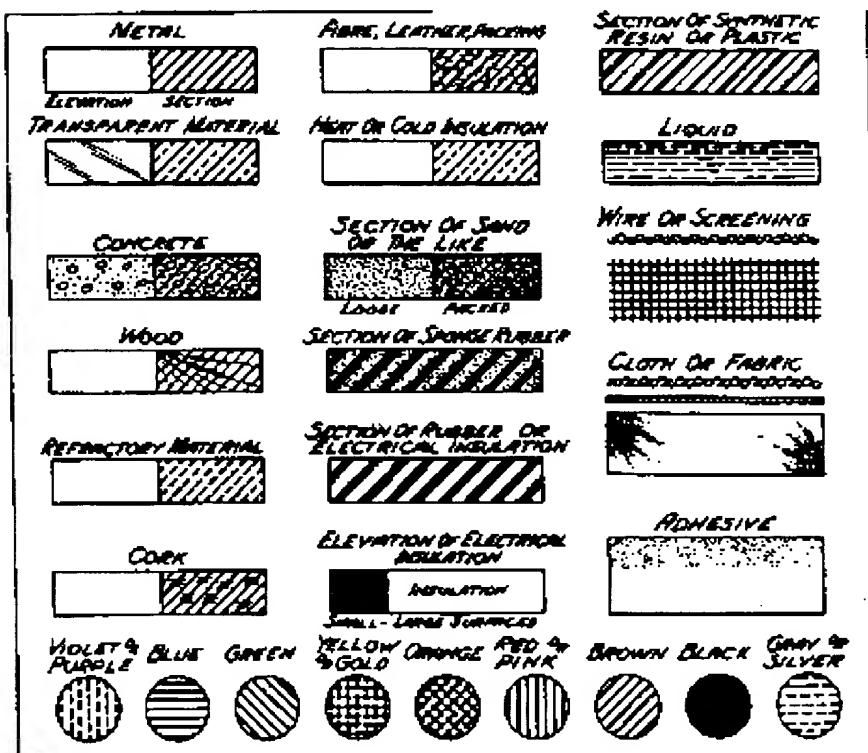
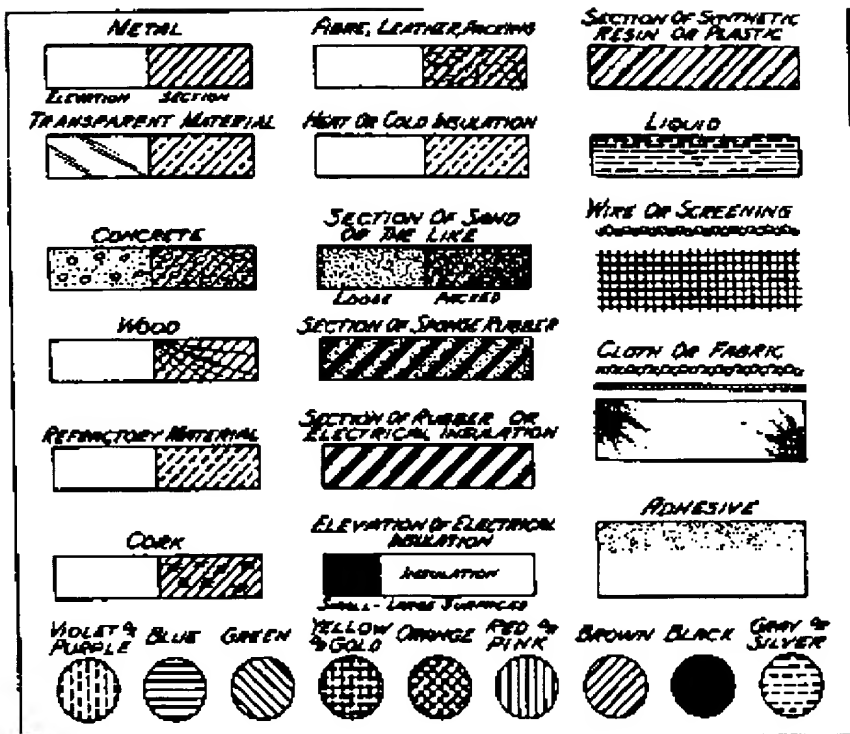
Fig. 1-8, and 15: Proper cross-sectional hatching is required to properly denote *metallic, transparent, and insulative* materials in accordance with MPEP 608.02 (see the drawing below for proper hatching examples). Moreover, all structures denoted by a darkened single line must be given a thickness and appropriately hatched in cross section for clarity.
